Planning and Zoning Commission

August 3, 2021

TO: Planning and Zoning Commission
FROM: Evann Martin, Assistant Planner
DATE: August 3, 2021
RE: Willow Hills Plat 1 - Final Plat

TO: Planning and Zoning Commission
FROM: Evann Martin, Assistant Planner
DATE: August 3, 2021
RE: B-Bop's – Site Plan

B-BOP'S
DIMENSION PLAN

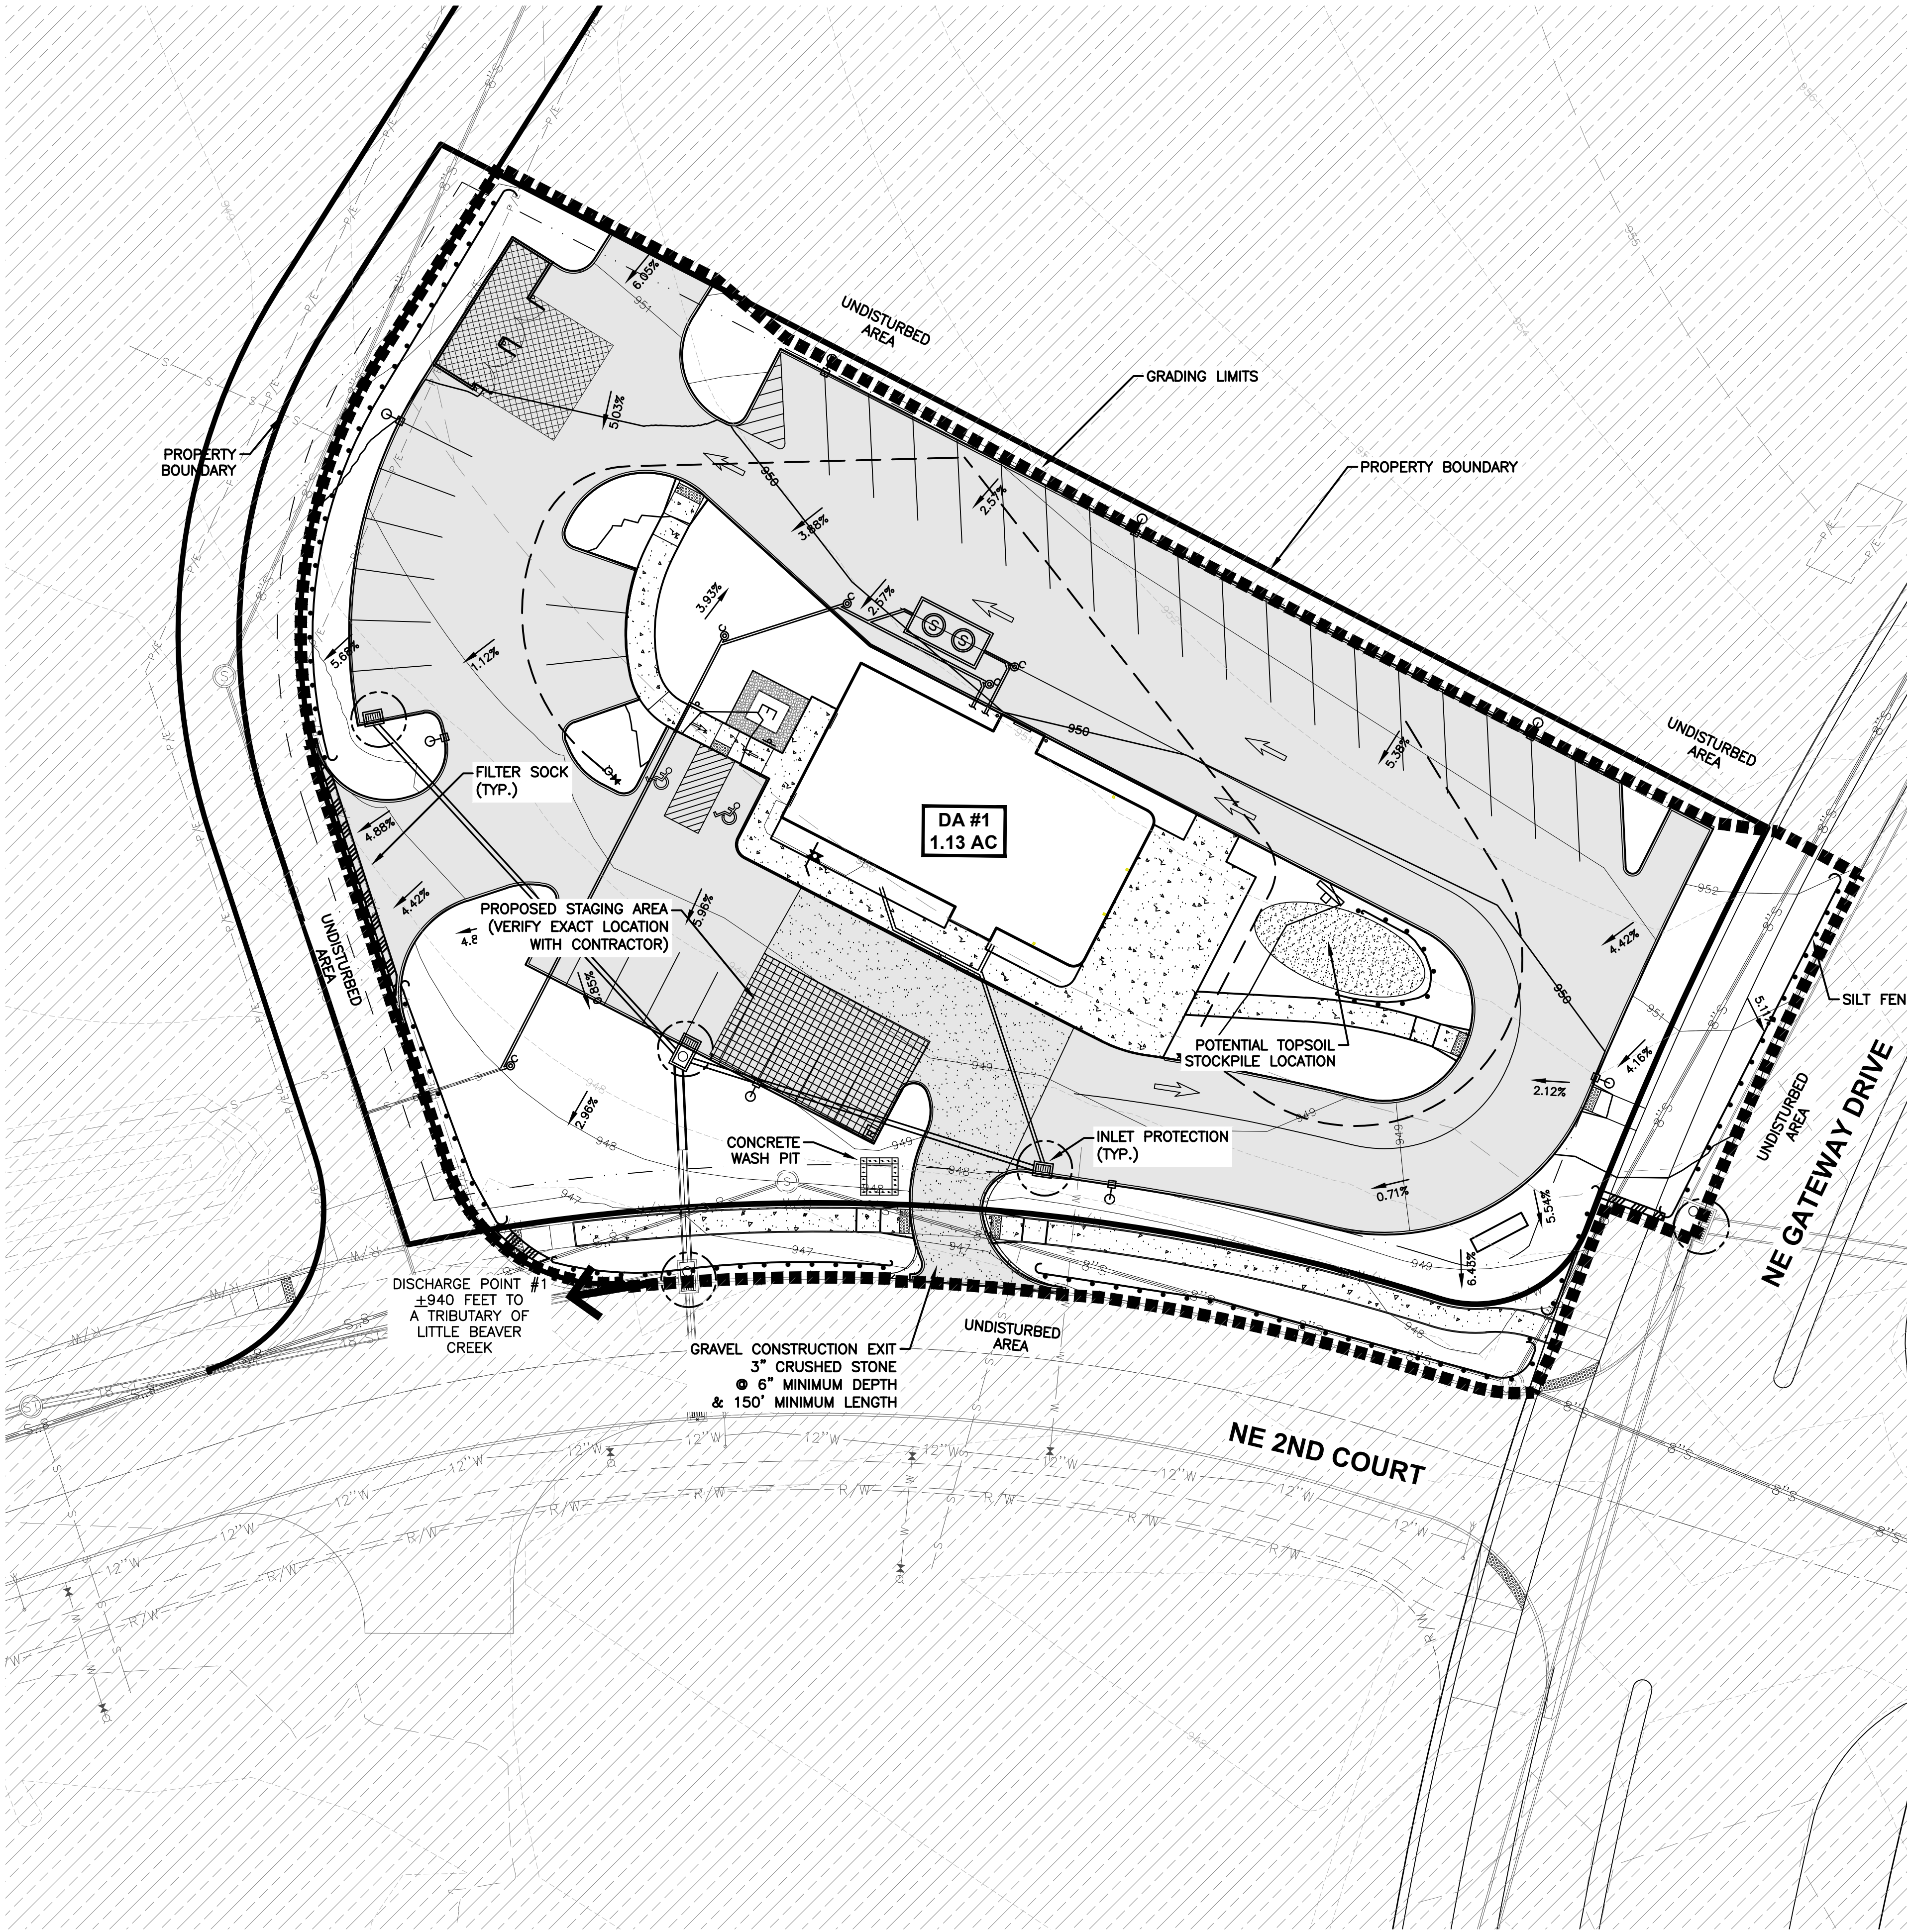
4. Provide a label of the parking stall depth in accordance with 165.34.4.C.1.b. **Please label stall depth for angled parking.**
5. ~~Label the width of the driveway off of the private street.~~
6. ~~Label the width of the driveway connection to the north.~~
7. ~~Are parking lot lights proposed? If so, please provide locations and cut sheets.~~
8. ~~Label sign location and provide entrance only sign detail for the right in driveway.~~
9. ~~Provide justification for providing more than 125% of the required minimum amount of parking spaces.~~
10. ~~Remove the driveway taper on the west side of the driveway off of NE 2nd Ct.~~
11. Please change the island at the NE corner of the site to a landscape island with curb.
Please do the same thing at the NW corner of the lot.
12. ~~The trail along NE Gateway is already in place. Please revise.~~

1 SOUTH ELEVATION
SCALE: 3/16" = 1'-0"

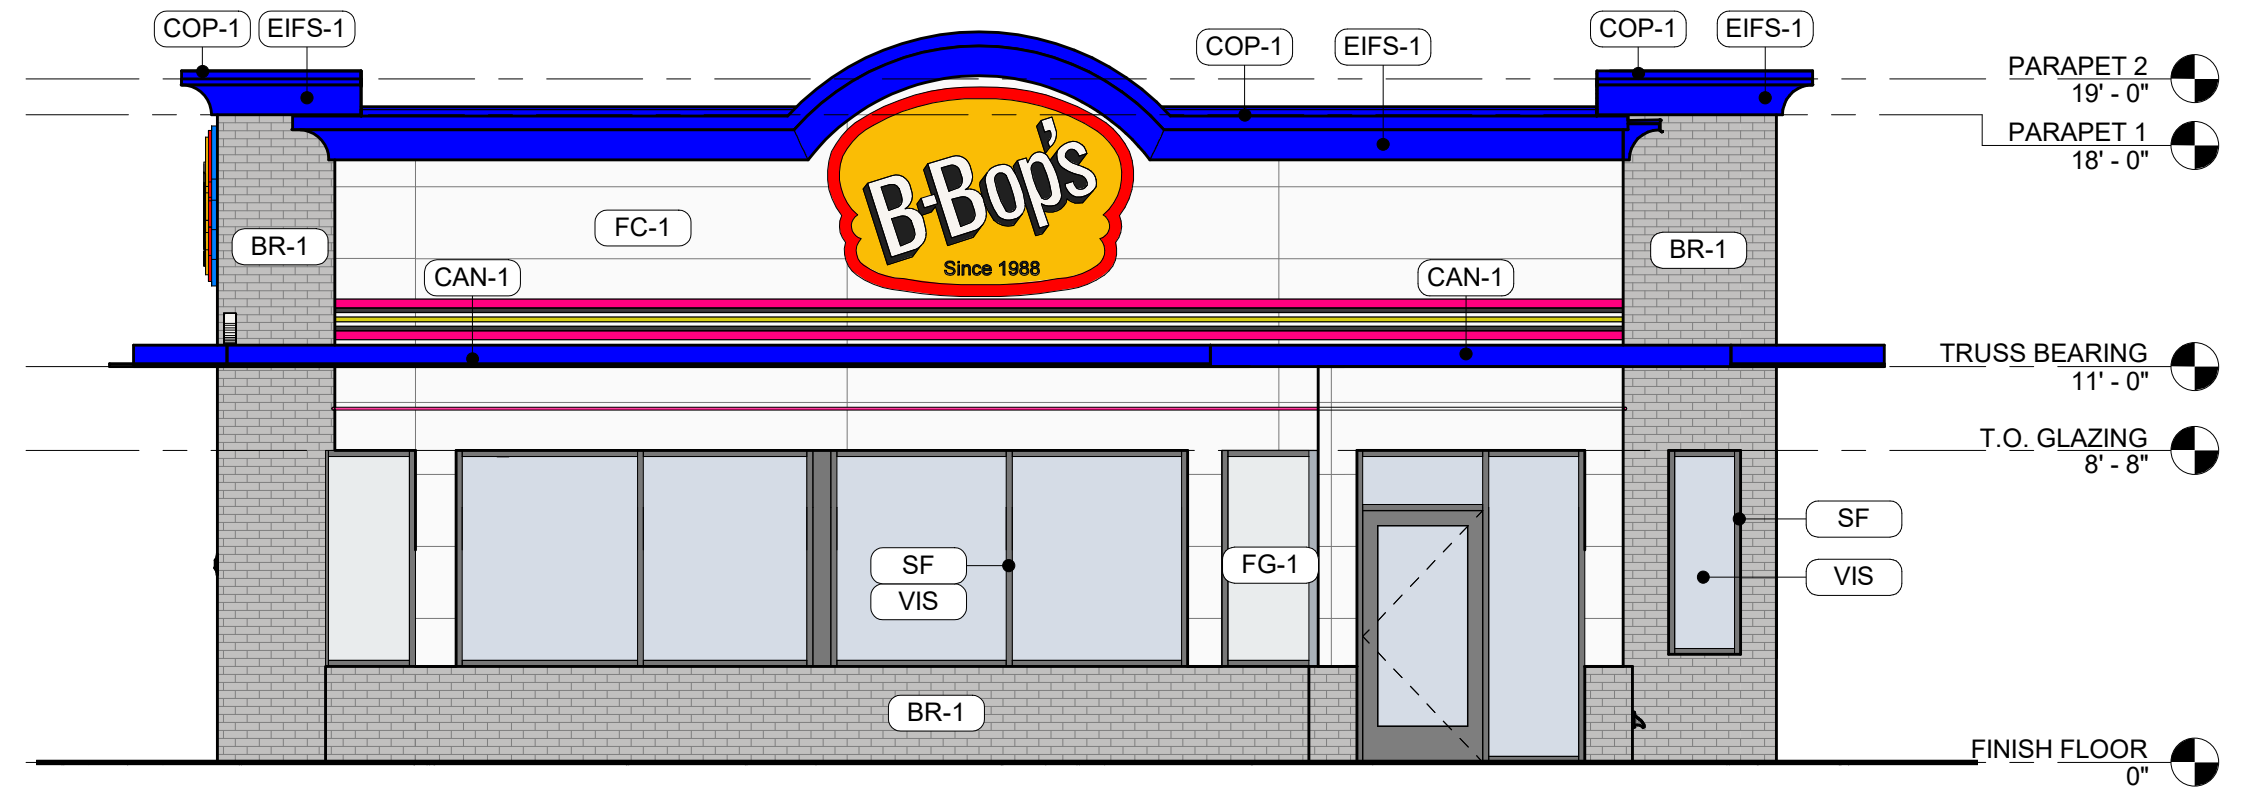
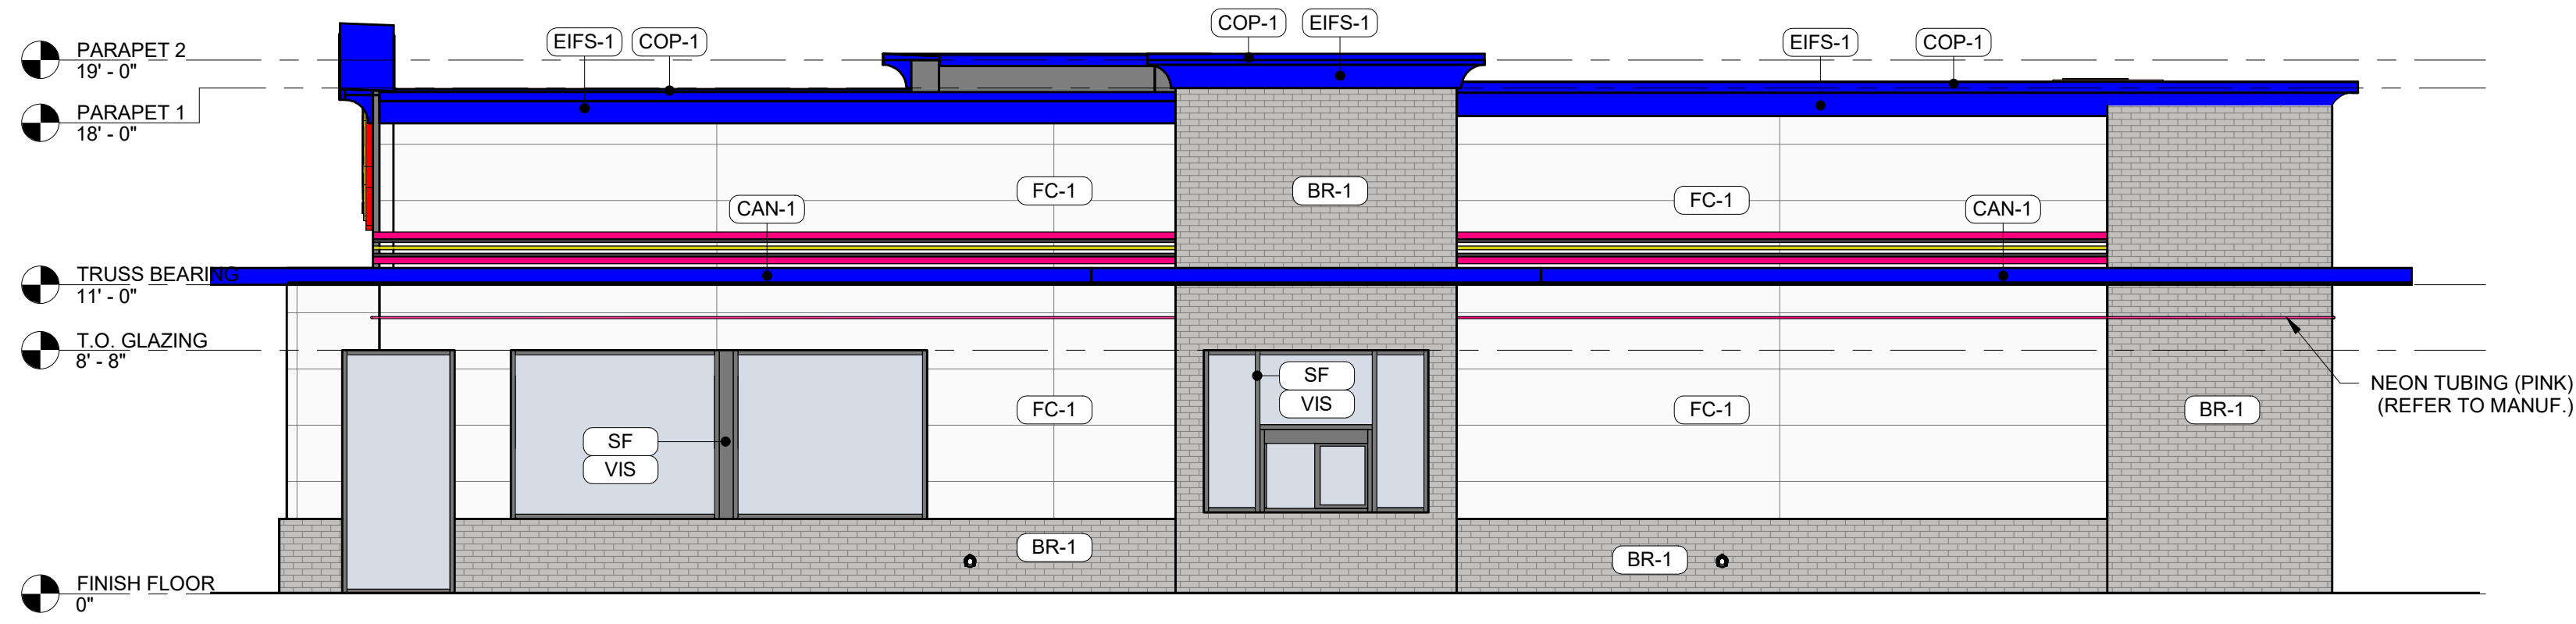
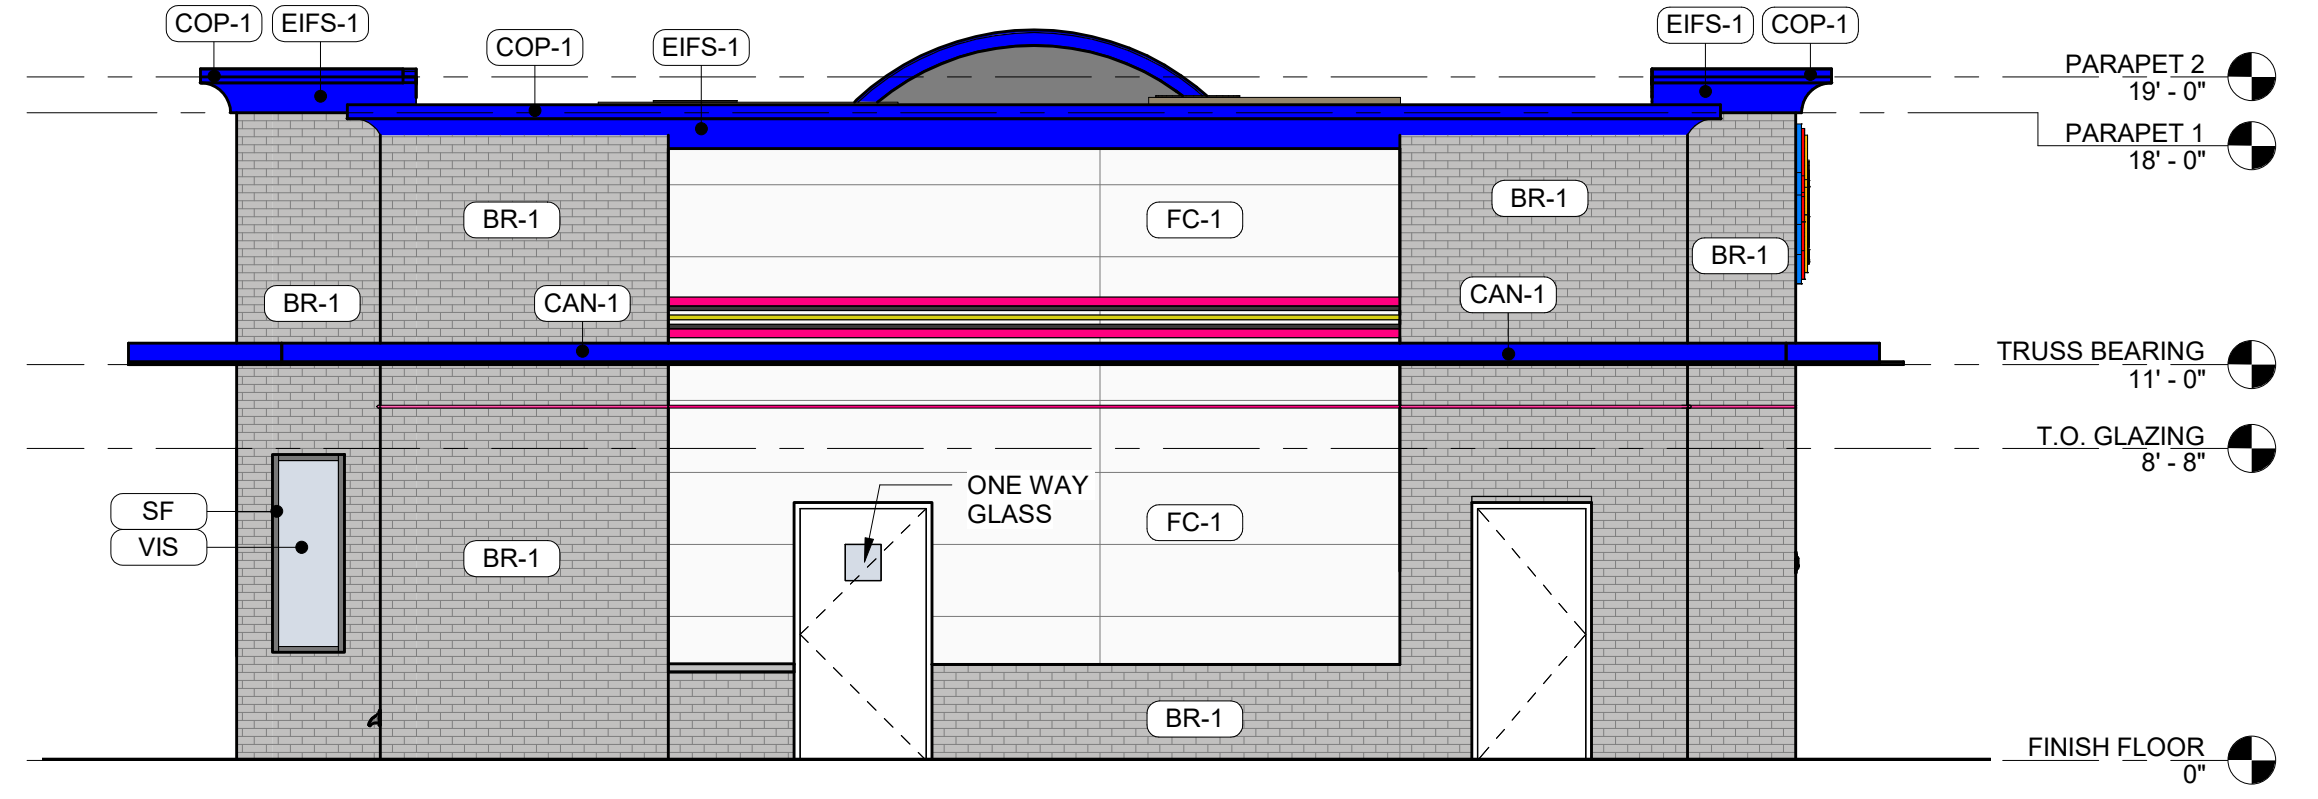
3. Are any colored lights or LED strips proposed? Please provide details for all planned lighting. P&Z and Council will need to review all lighting. Any lighting not approved by P&Z/Council will be required to be return to public meet for approval. What colors are proposed for the lighting? Please label lighting locations and colors on the elevations. If the pink neon tubing the only colored lighting?

4. Are the colored stripes above the canopy painted or will there be neon lighting as well?
- ~~5. Any roof mounted equipment will need to be screened. If parapet walls will not substantially screen the units, provide a screening detail (material, color, etc).~~

- ~~6. Provide building material and glazing percentages.~~
7. A minimum of 40% of the length of the building at eye level along the ROW is required to be glazed. Please provide calculation for the east elevation.

9. Metal paneling is not permitted. Concrete panels could be substituted. In this case, the building would require a 4/5 vote of approval by Council. **Please provide/label decorative reveals and hidden fasteners for the fiber cement.**
10. **Label the height of the dumpster enclosure and exterior storage structure.**
